UNITED STATES  
NUCLEAR REGULATORY COMMISSION  
WASHINGTON, D. C. 20555

Subject: Amendment No. 25 to Facility Operating License No.  
NPF-22, Susquehanna Steam Electric Station, Unit 2

This amendment revises the Technical Specifications to change the setpoint for main steam isolation valve (MSIV) closure on reactor vessel water low level from Level 2 to Level 1.

ATTACHMENT TO LICENSE AMENDMENT NO. 25

BASES FIGURE B 3/4 3-1  
 REACTOR VESSEL WATER LEVEL

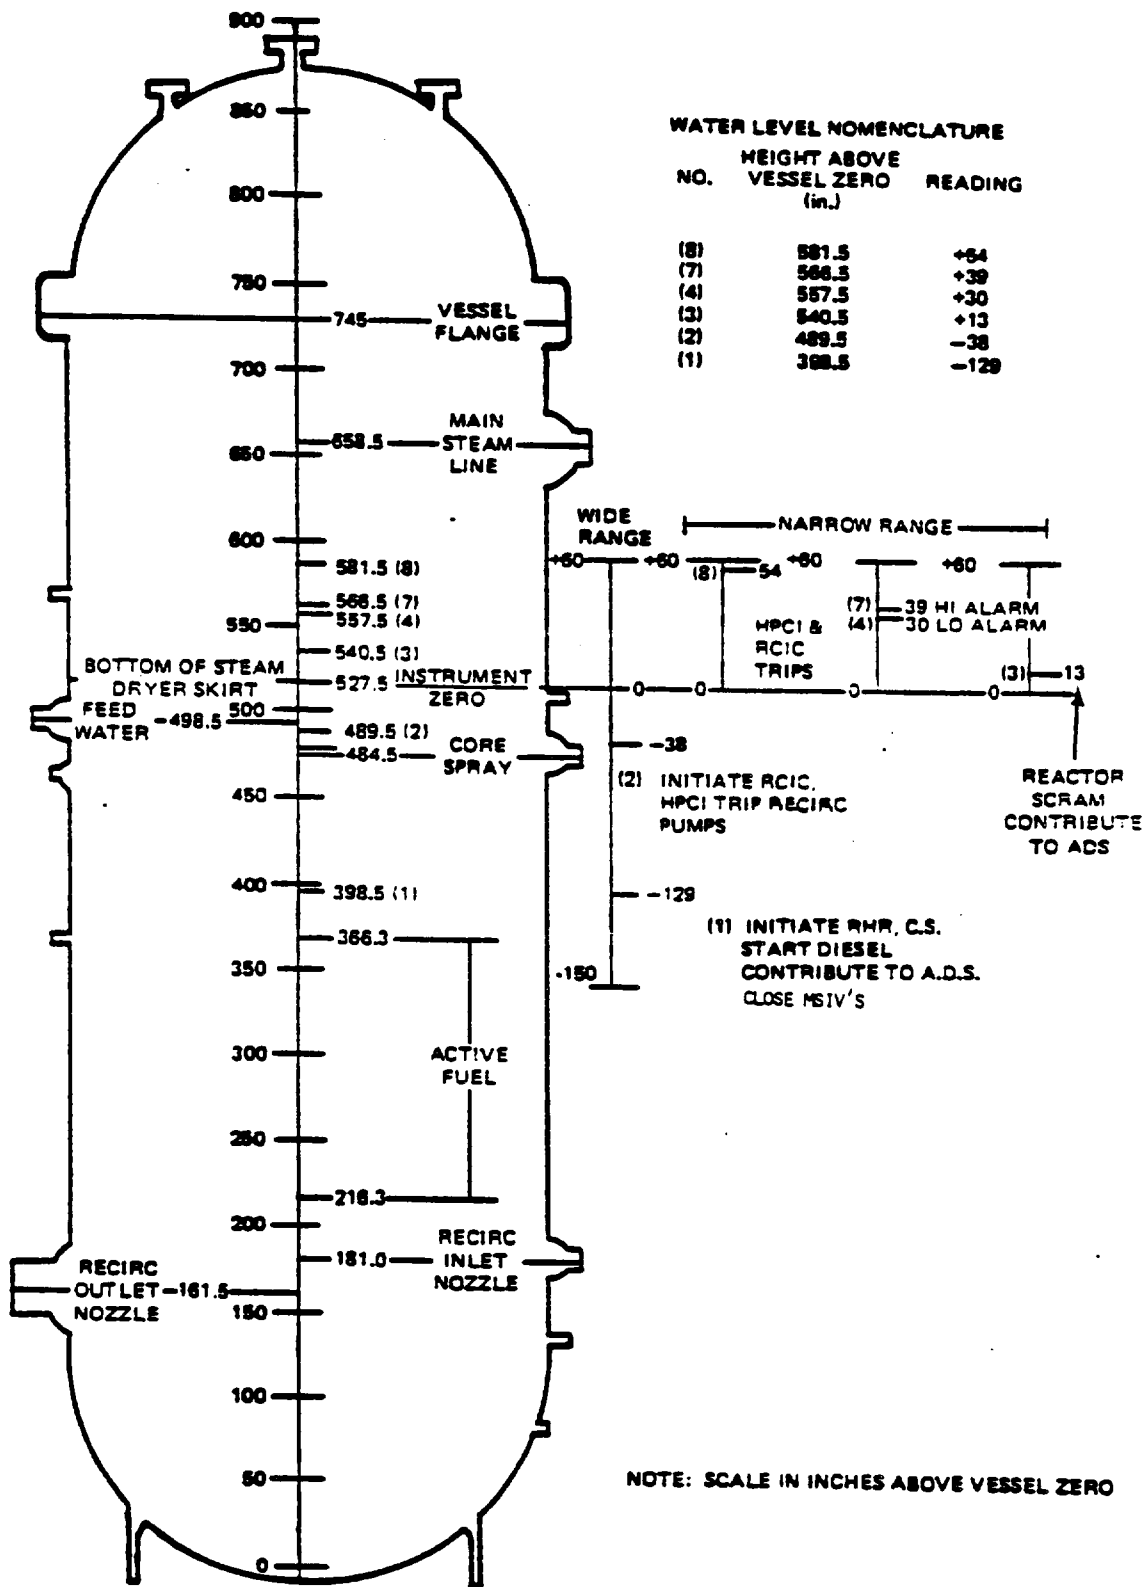
The licensee proposed changes to the Technical Specifications of the operating license for Susquehanna Steam Electric Station, Unit 2 to lower the setpoint for main steam isolation valve (MSIV) closure from low water level 2 (Level 2) to low water level 1 (Level 1).
